Showplace Square/Potrero Hill Area Plan December 2008

MUNA – Verdi Club Issues with 480 Potrero Development Plan

- 4-2-2013 480 Potrero Project Plan: Six Story, 58 ft, UMU, 77 residential units, (29-1Bd, 40-2Bd, 8-3Bd), 974 ft Retail space, 46 parking, 31 bike parking

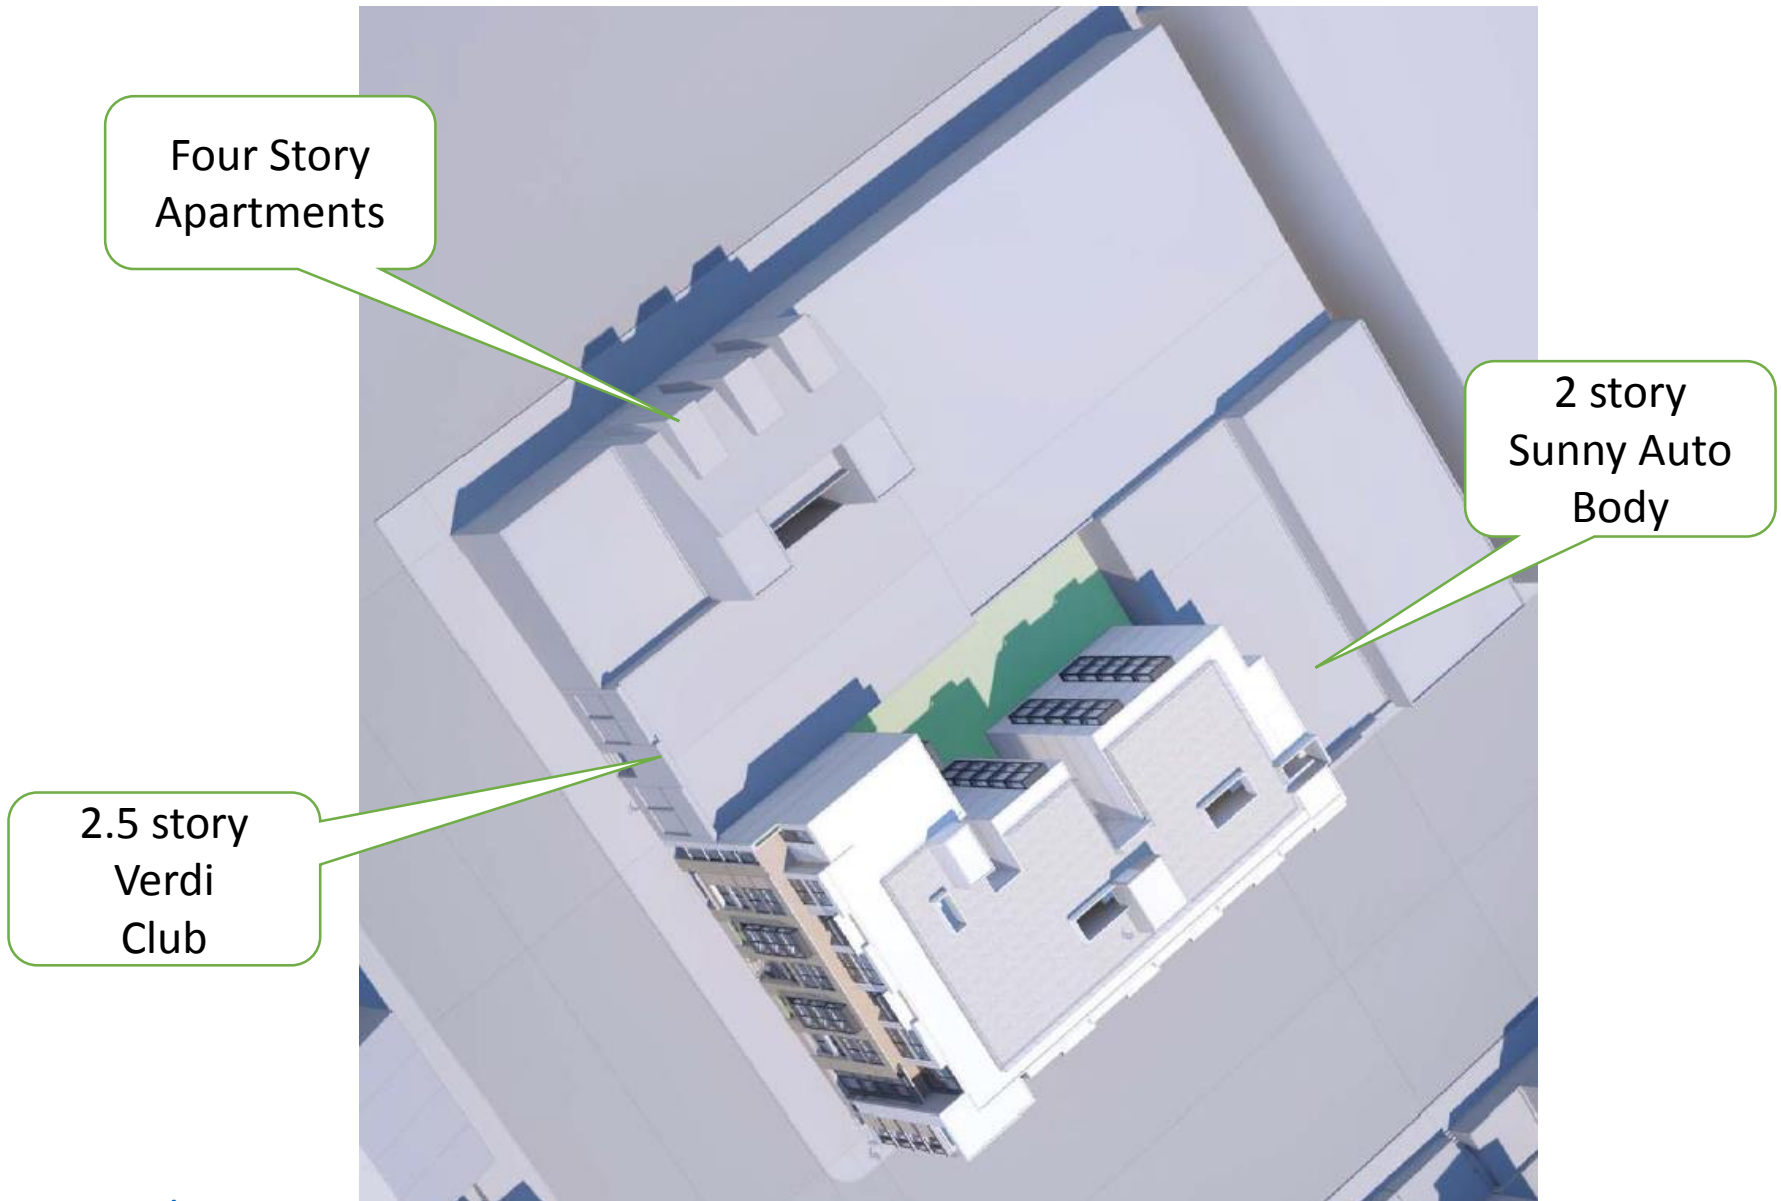
Verdi Club is 2.5 stories. Sunny Auto body is 2 stories. 6 stories plus an additional elevator shaft, stair wells, fencing for “open space” is out of the neighborhood scale.

The height of the proposed building is substantially taller than it's neighbors.

Title: 480 Potrero
Comments: Height Modeled at 68 Feet
Slopes Taken into Account
Printed: 6 September, 2012

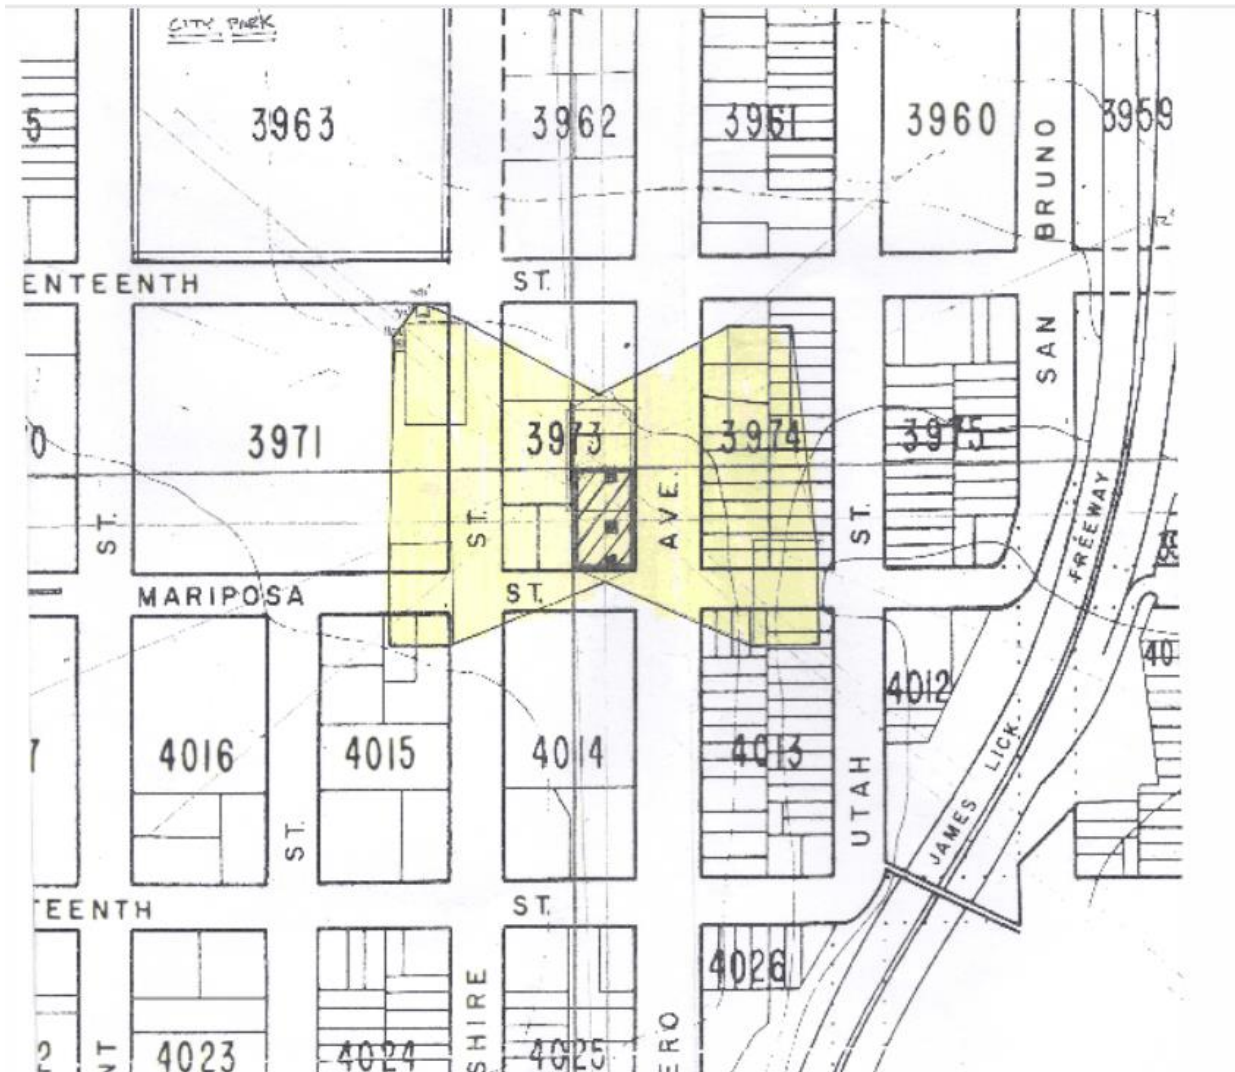
6 stories is significantly higher than the surrounding buildings and will cast a significant shadow on the gardens of homes on the east side of Potrero.

Shadow Analysis from SF Planning shows gardens in shade.

P4 Motion No. XXXXX Case 2011.0430X

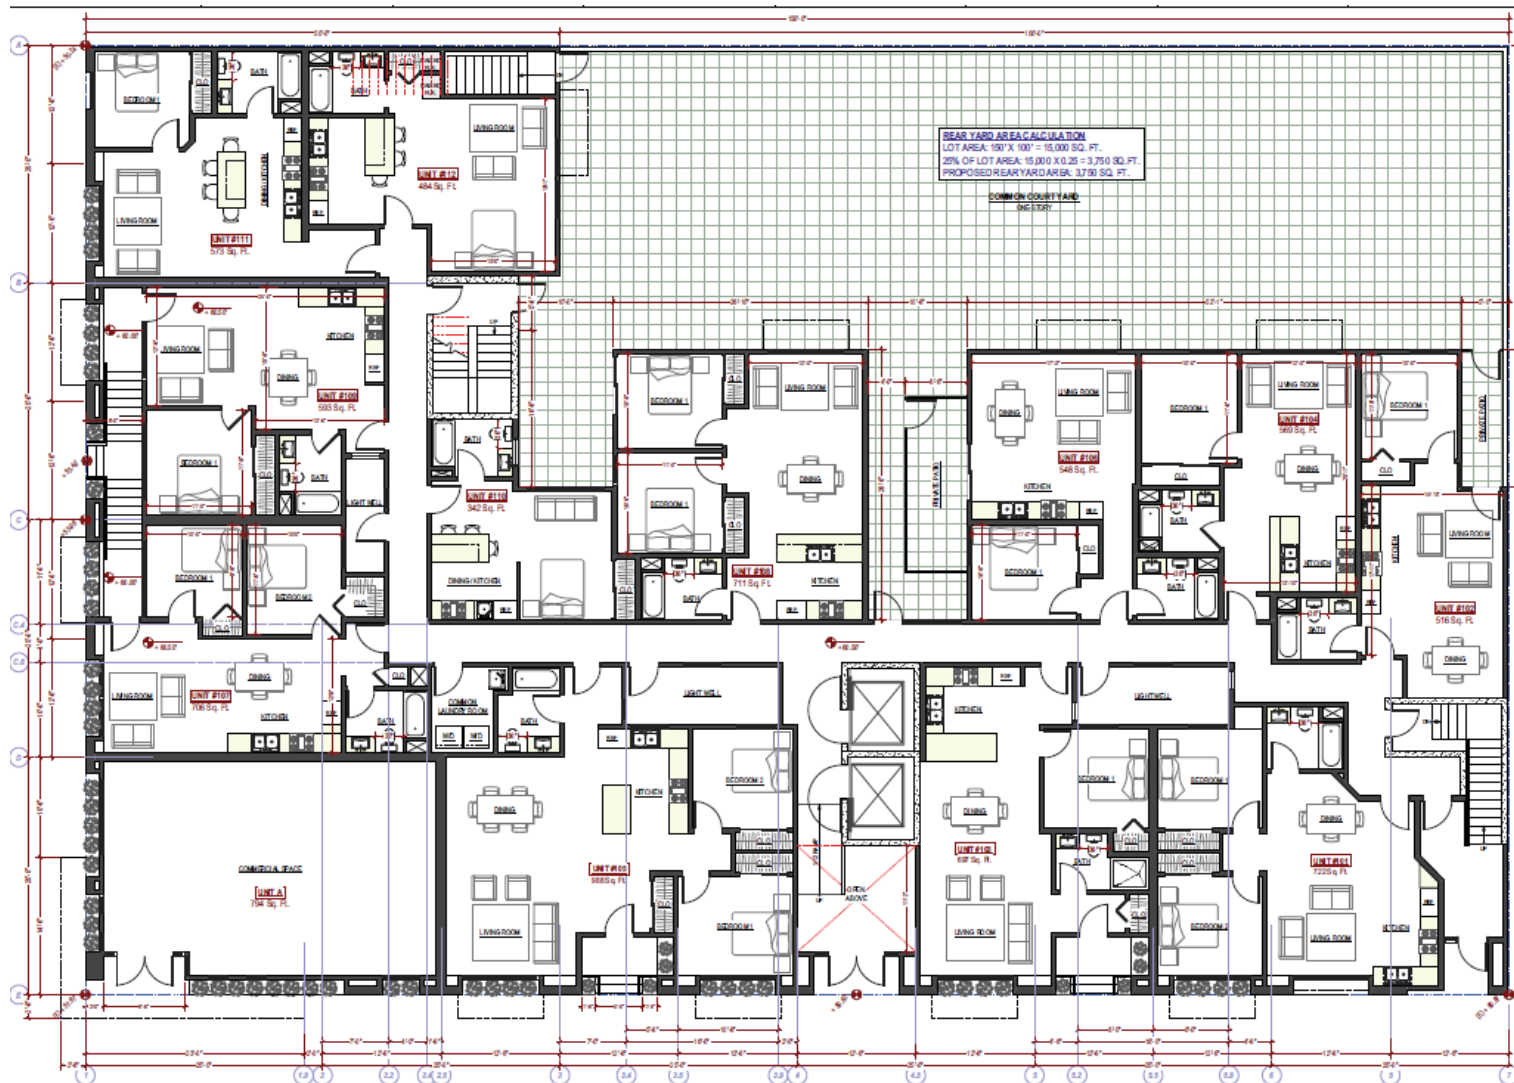
There is no way that the public can access this open space so it must be considered private. In order to reach 6160, SIA included the roof which is not quality usable open space.

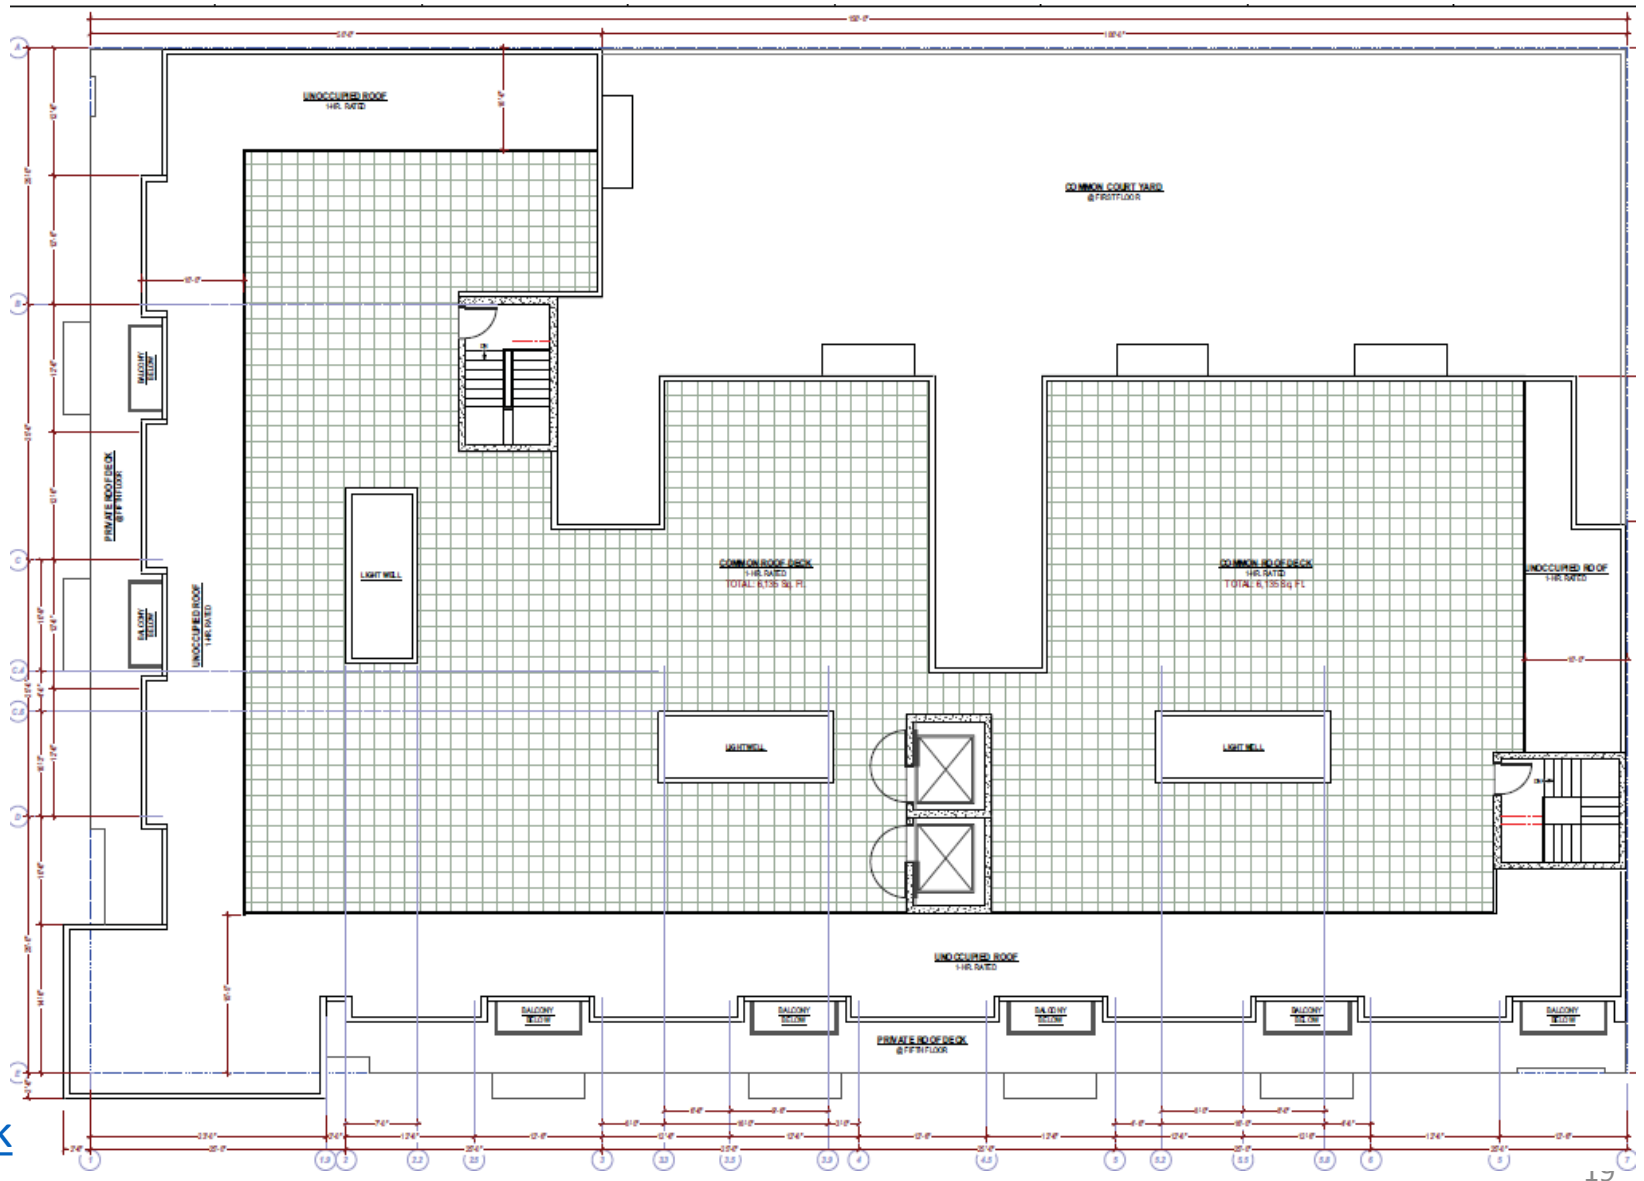
Open Space is on the first floor, above the garage. This is not a place for gardens or trees. The large rectangle is $100 \times 32 = 3200$ feet and less than the required 3750 feet. In order to get to 3750 SIA has added small rectangles which include private balconies

Additional open space is on the roof. This will require at least 3 feet of fencing above the 58 foot planned roof height.

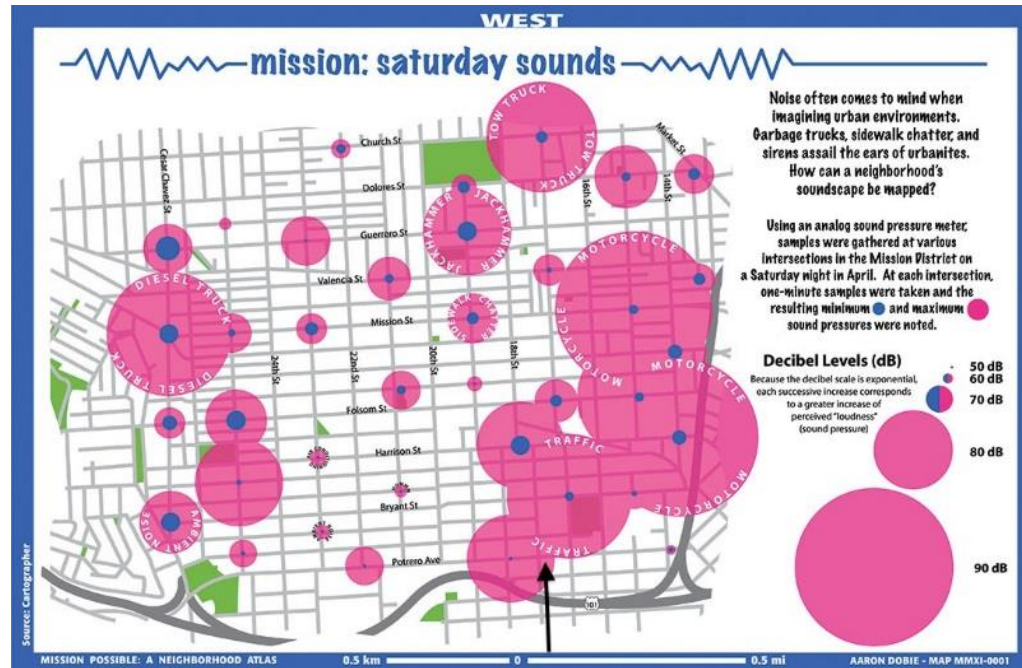
- The firm was extremely concerned about potential damage from vibrations to nearby buildings, including the Verdi Club, during the drilling and excavation phase.

- Engineers considered underpinning the Verdi Club to protect it from damage during the excavation phase when it was set at 11 feet. The new proposal refers to a 16-foot excavation, which could, create a new set of issues including ground water issues.

- Since the project is located at the base of the extremely hard serpentine subsurface that covers most of Potrero Hill, the engineers insisted on monitoring the project and making adjustments in their calculations as the drilling proceeded. Neighbors need assurances that this will be the case with any new projects developed on the site.

- Due to the extremely hard subsurface, insufficient soil samples have taken so far. We request a proper soil sampling be done prior to any approval for development.
